Further Representation – Planning Application DC/26/0980

Photo 3 – View from the bedroom window towards the raised decking and walkway.

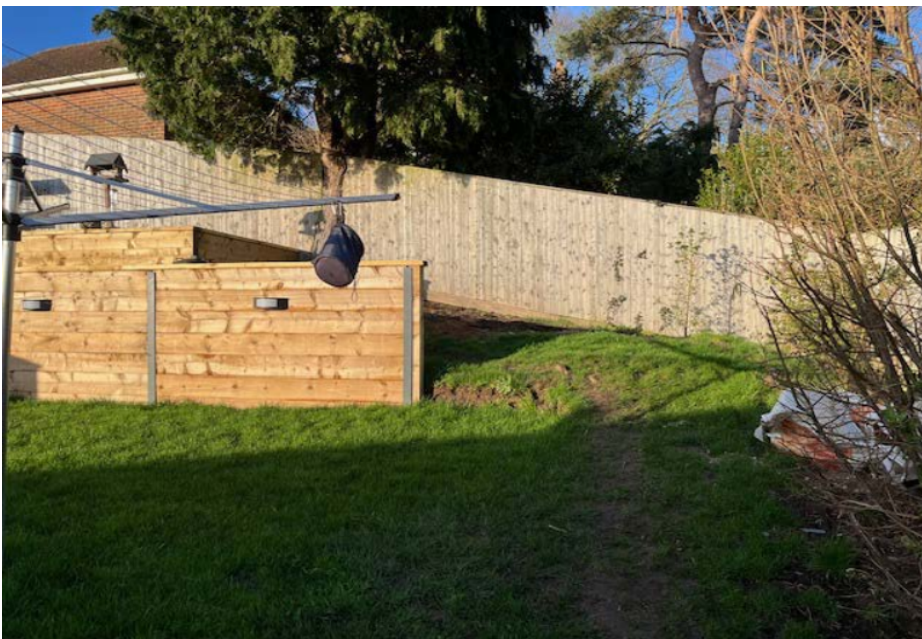
In any event, the principal privacy concerns are not confined to this area. The areas of greatest concern relate to the raised platform and the gravel walkway, which would create elevated positions from which there would be direct sightlines into my bedroom windows and towards my garden. These overlooking impacts cannot be effectively mitigated by screening, as any screening sufficient to prevent these views would need to be approximately 4 metres high and would be unacceptably overbearing.

I have also included a further photograph taken from my bedroom window towards the gravel walkway and raised platform, to demonstrate the direct overlooking from anyone standing on the raised platform or using the gravel access path to the raised platform.
